# A G E N D A

## Architectural Review Board

December 15, 2021 – 5:30 p.m.

1919 Norman Bridge Road

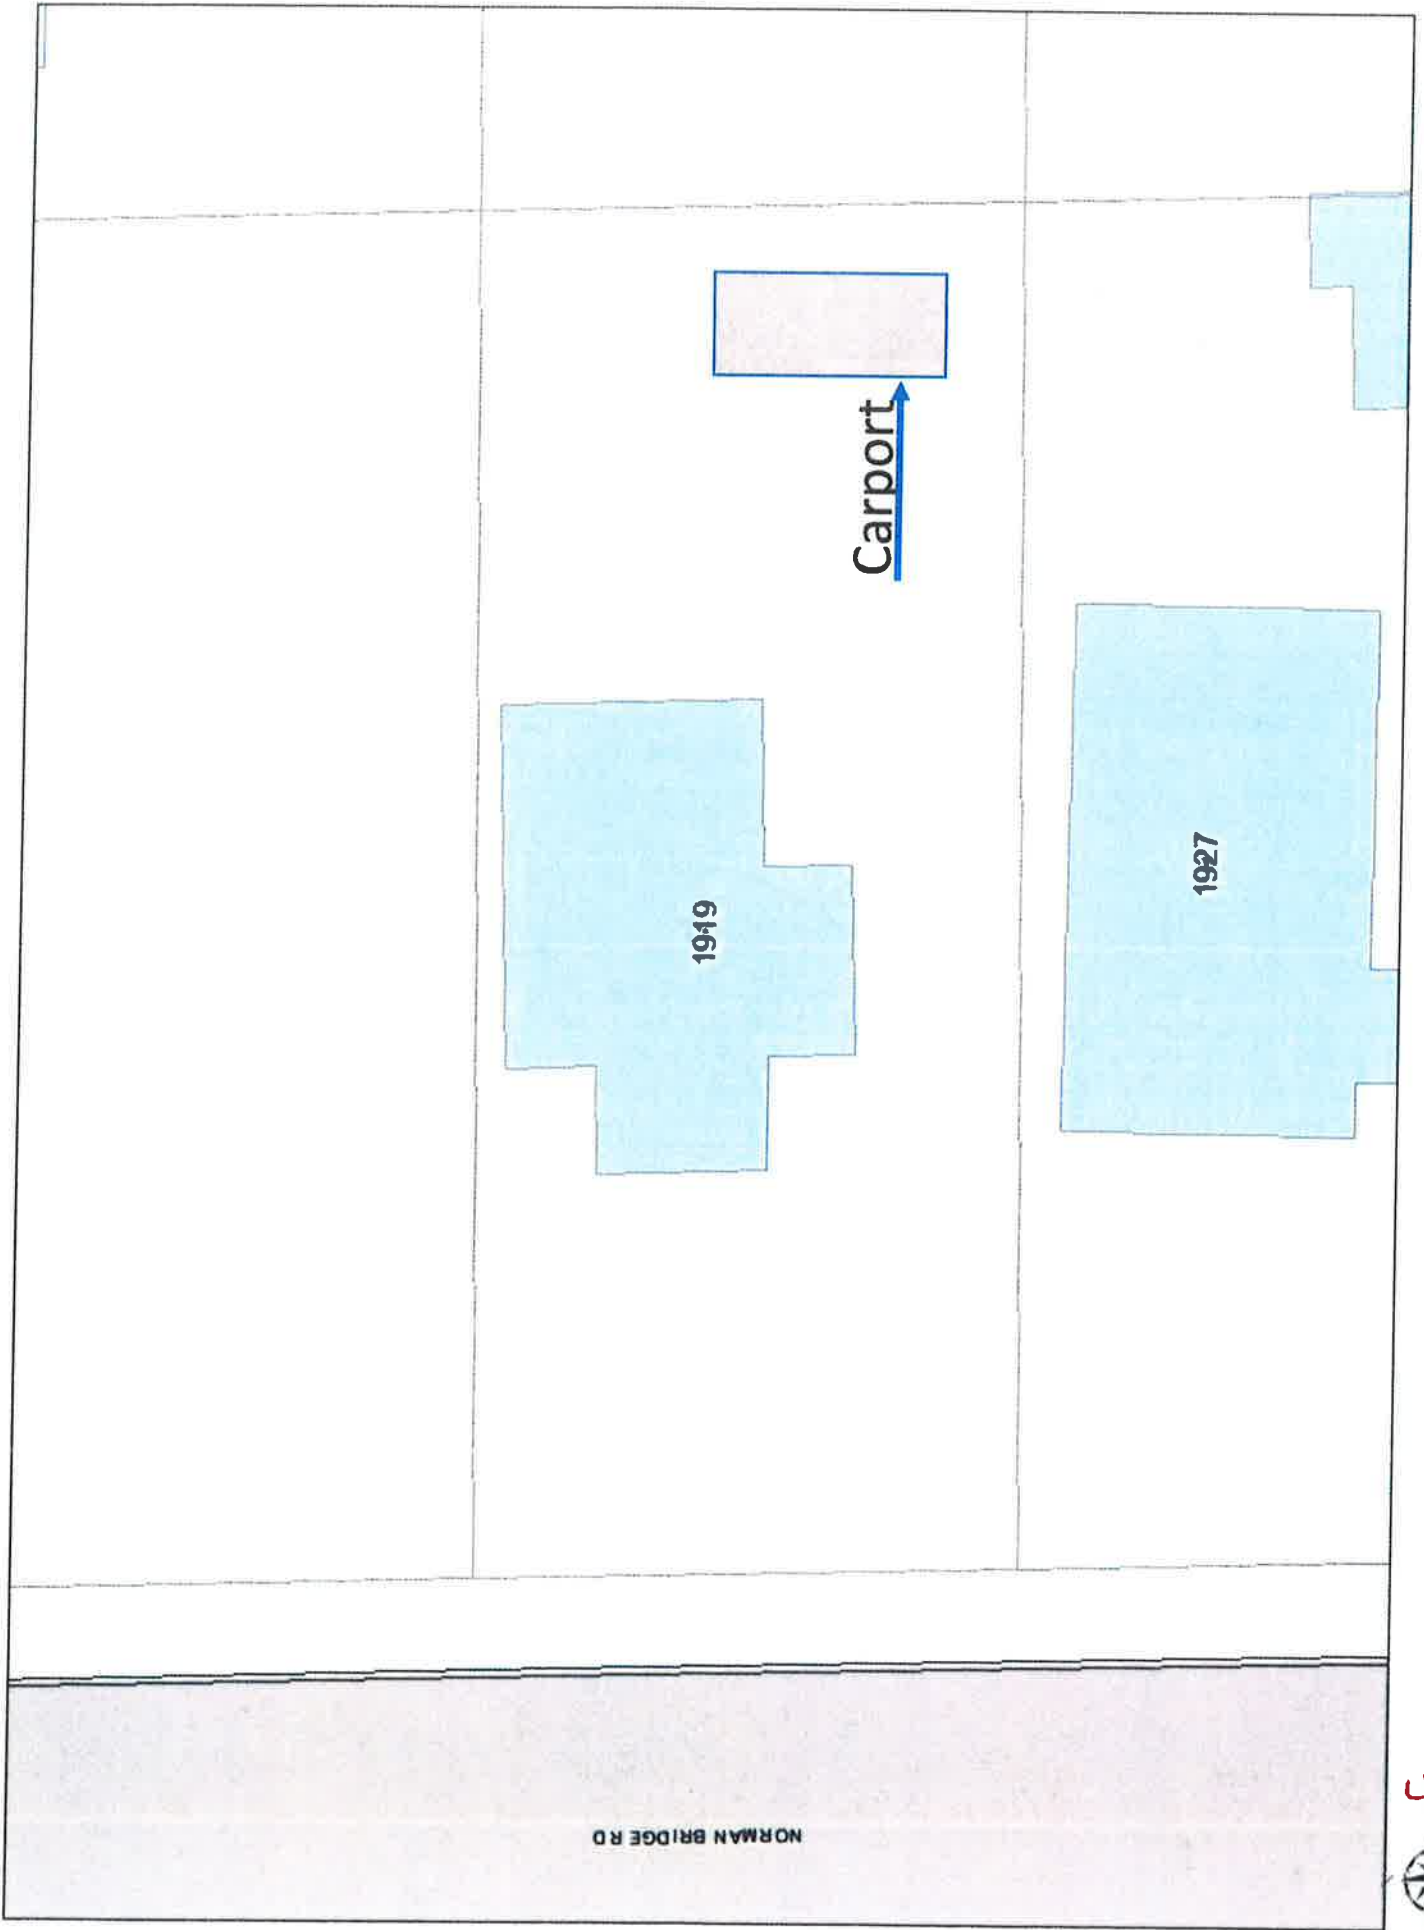
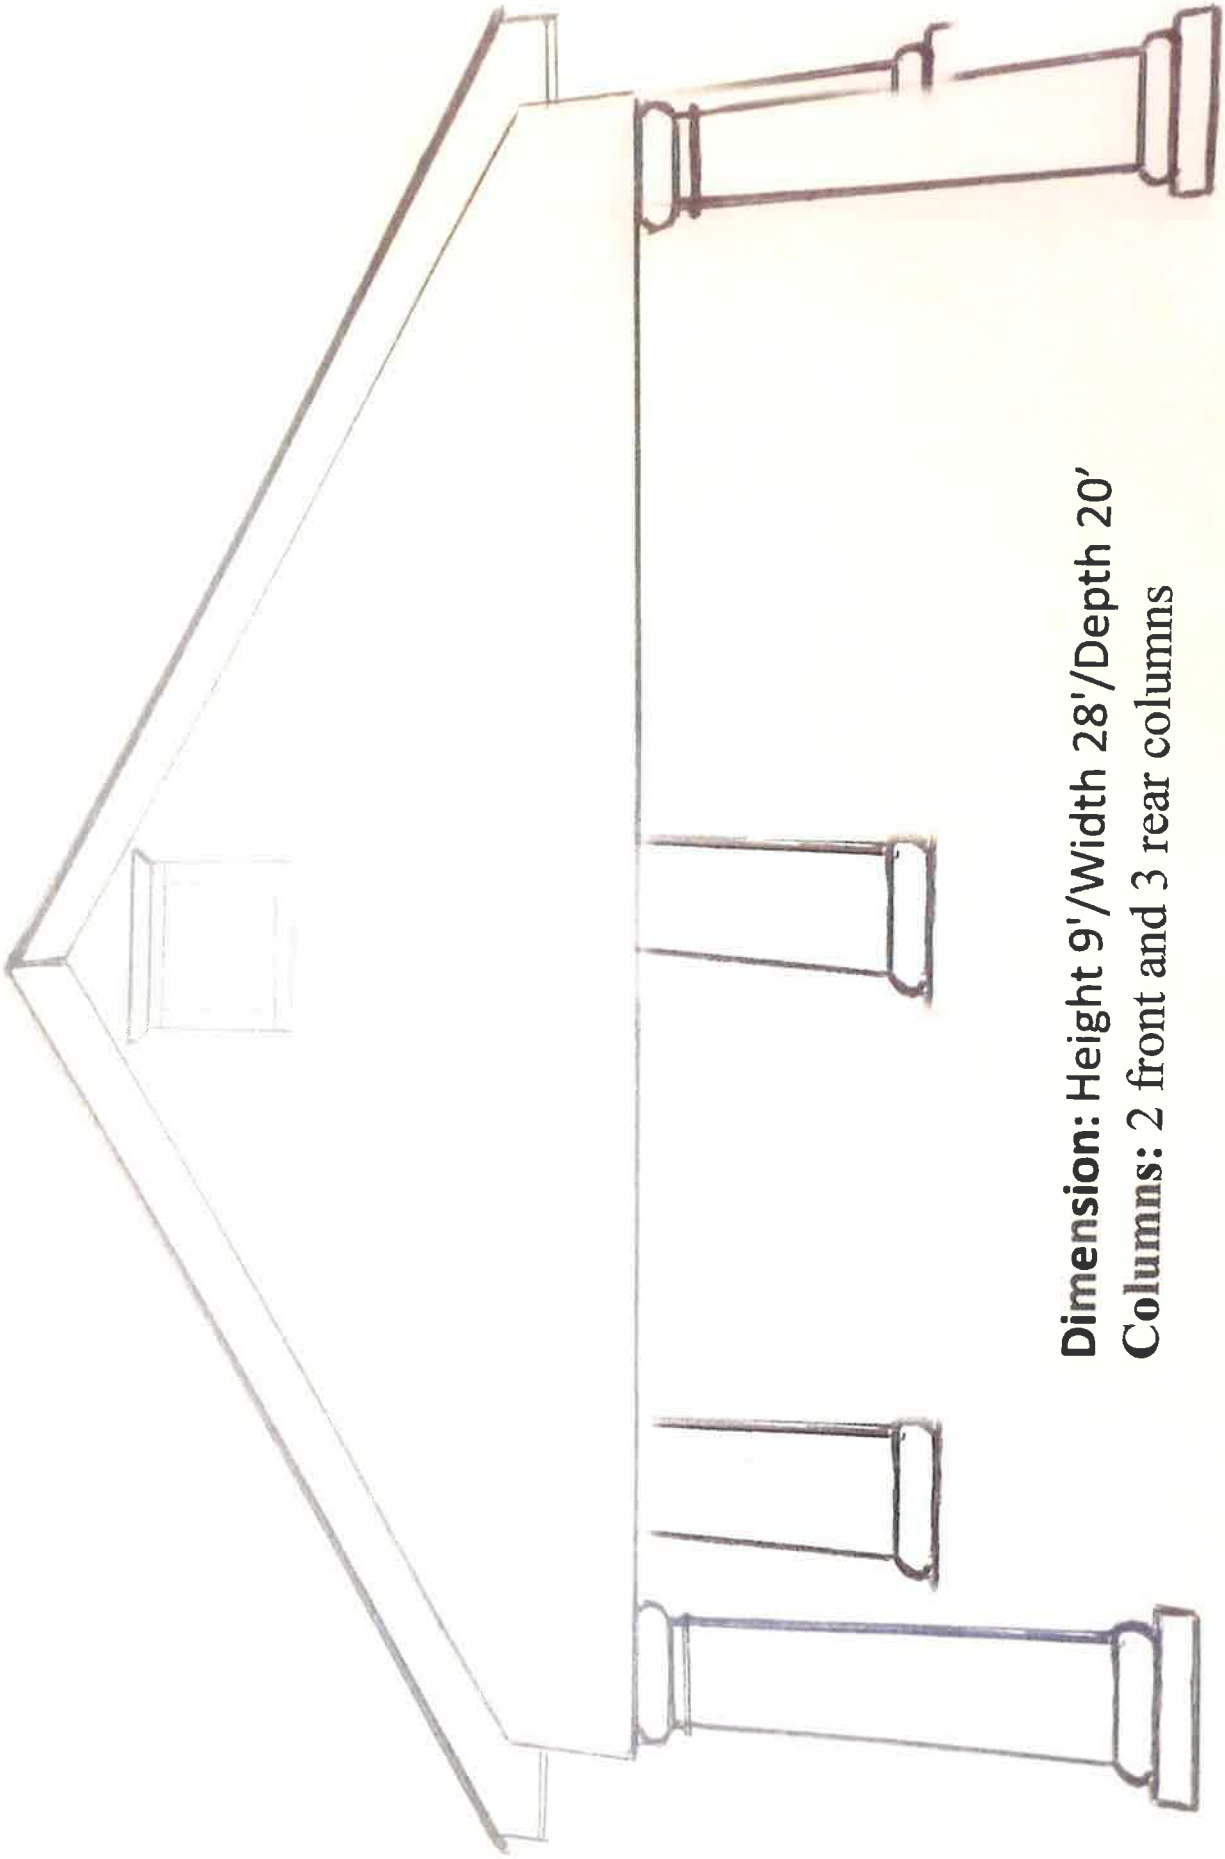
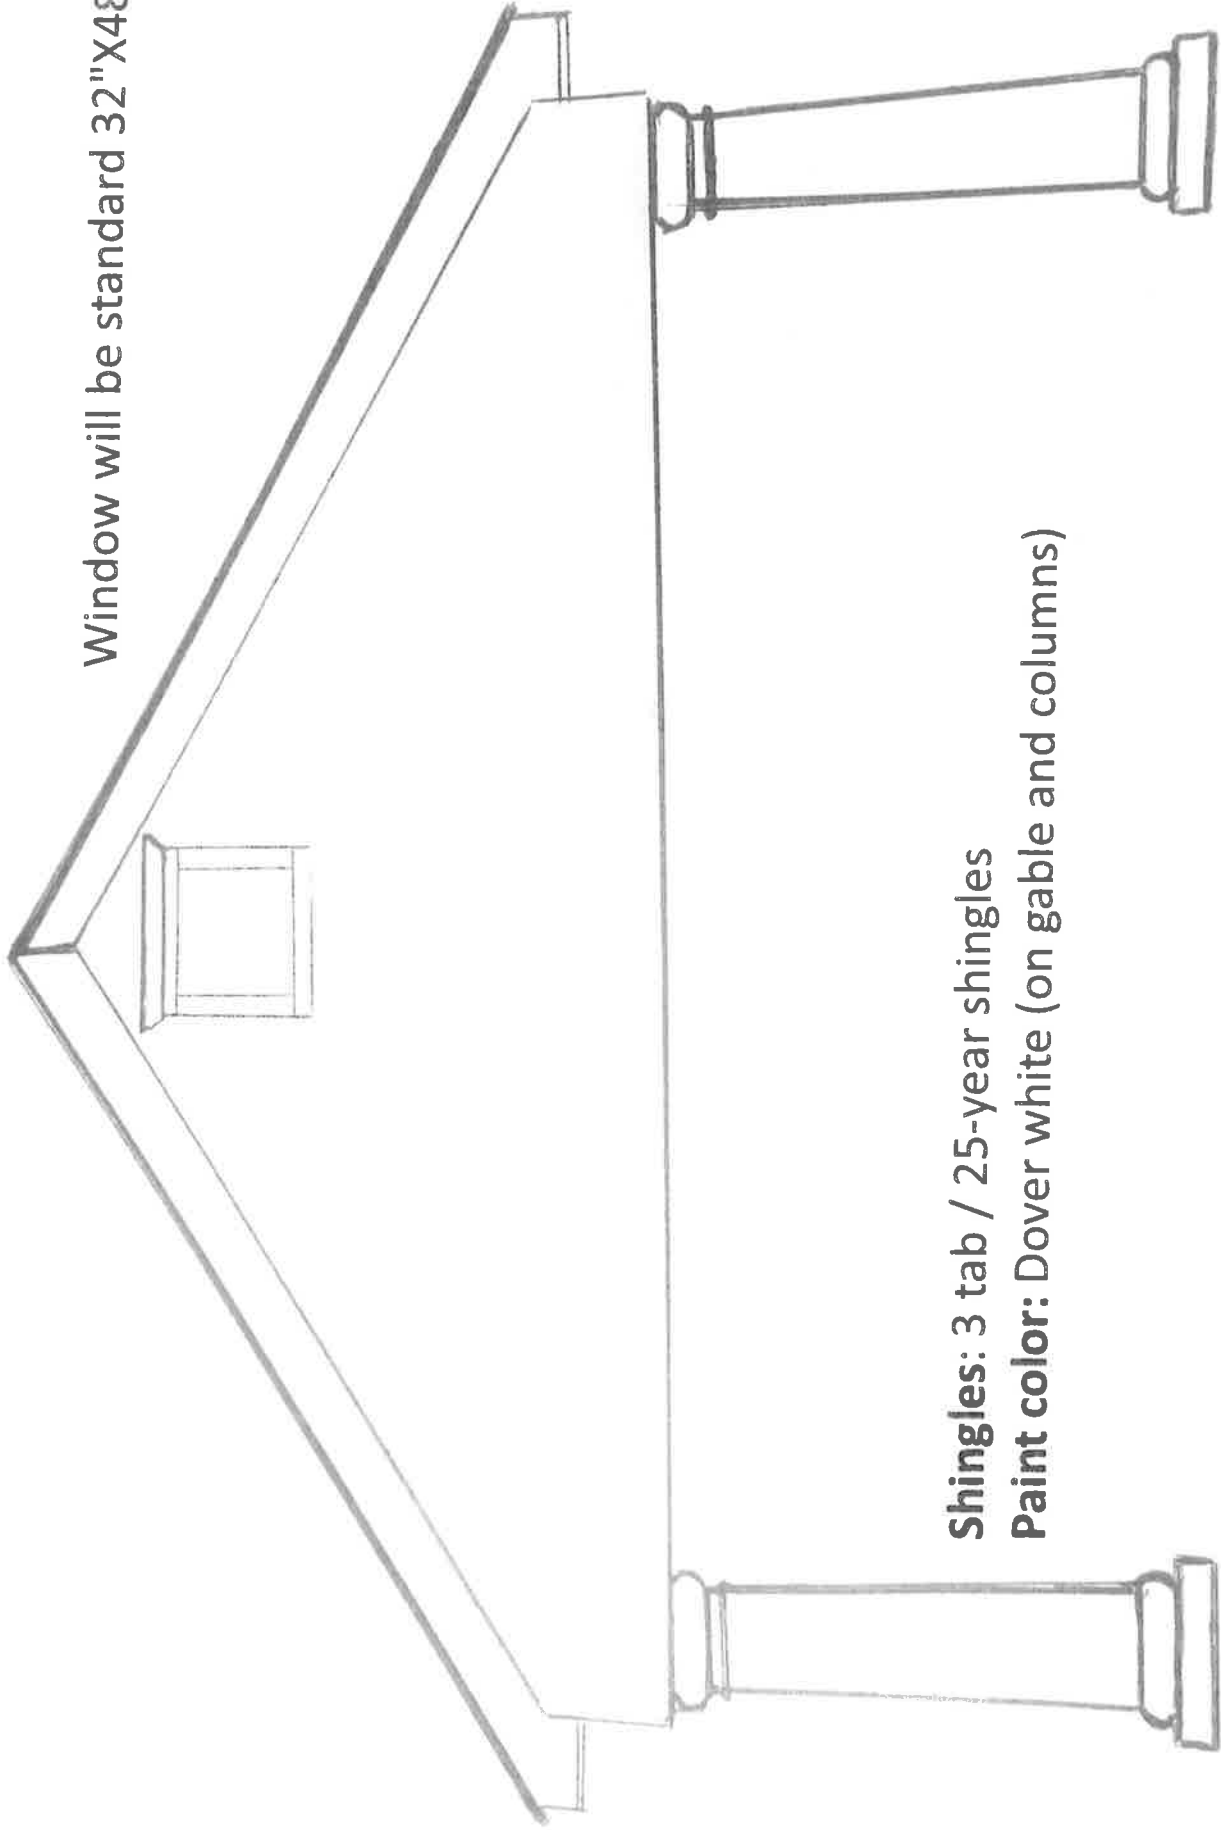
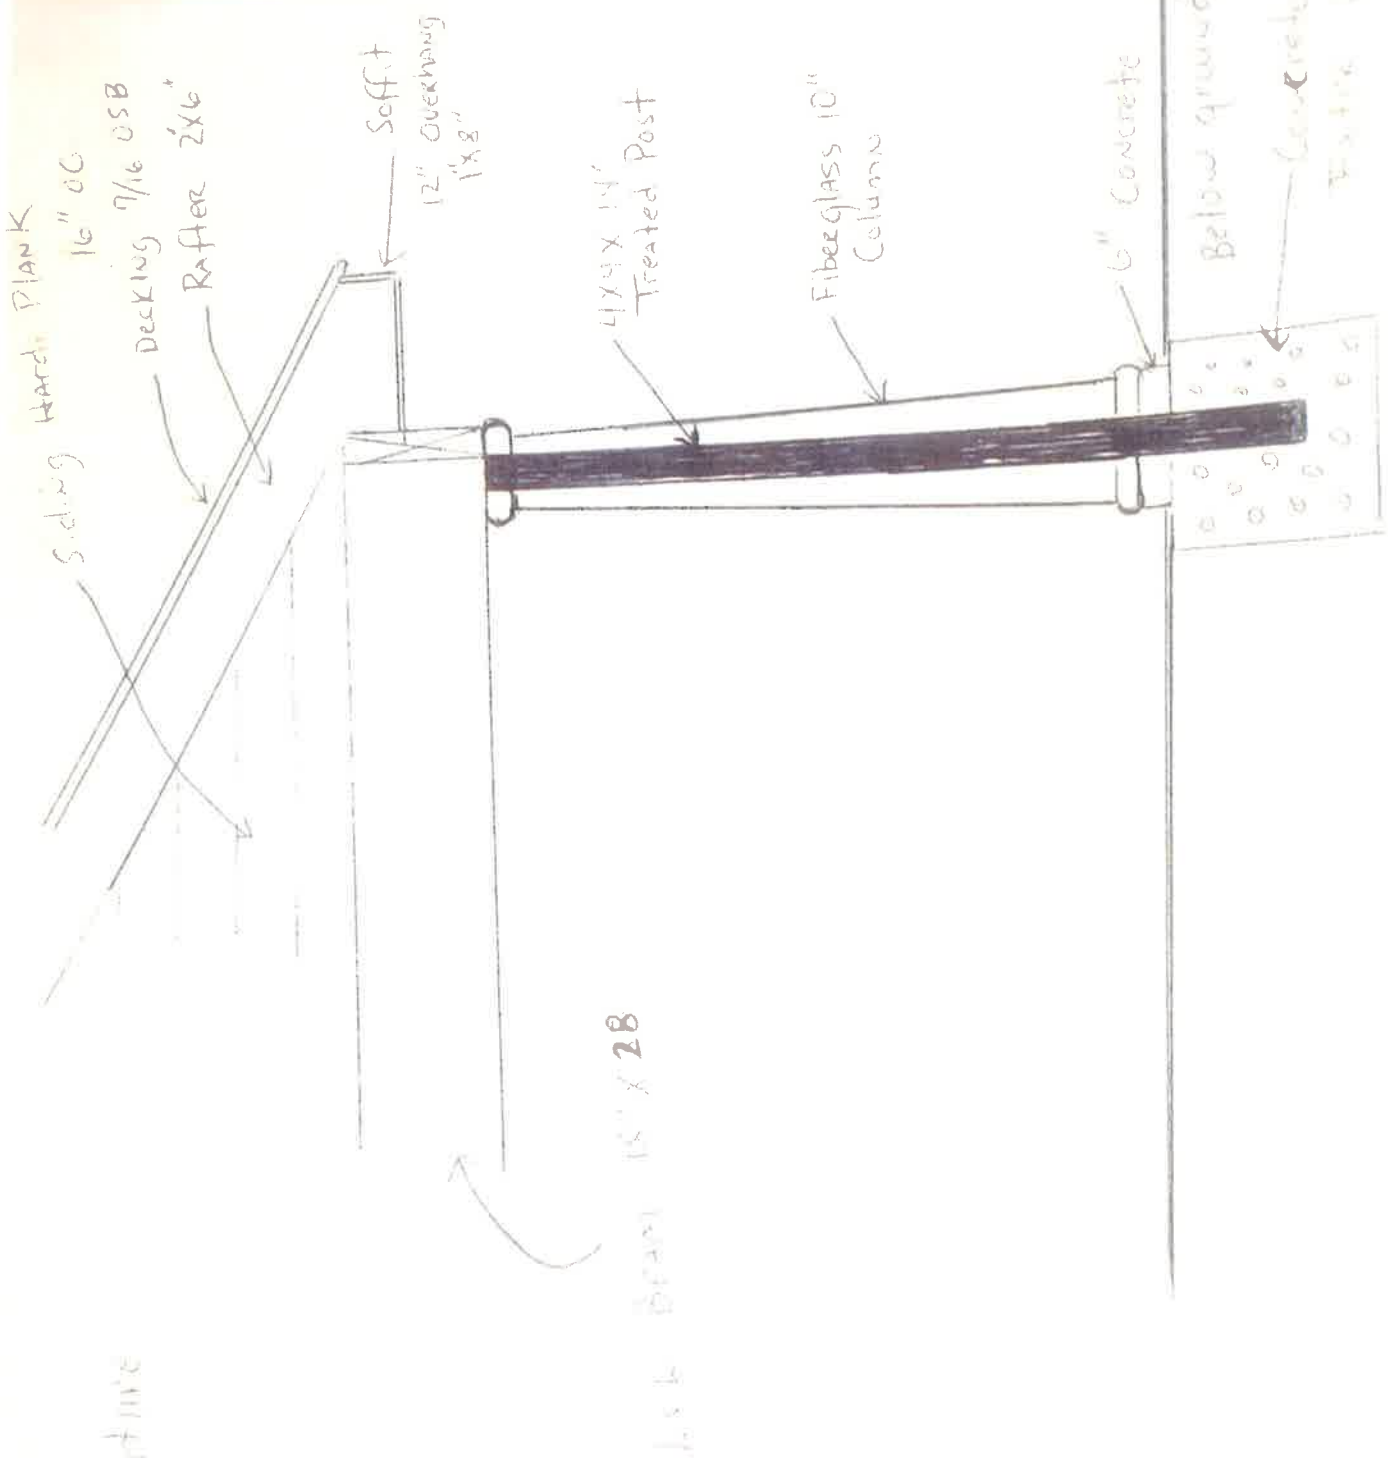
- This is similar to one previously approved on Felder Avenue in Cloverdale. No objection.
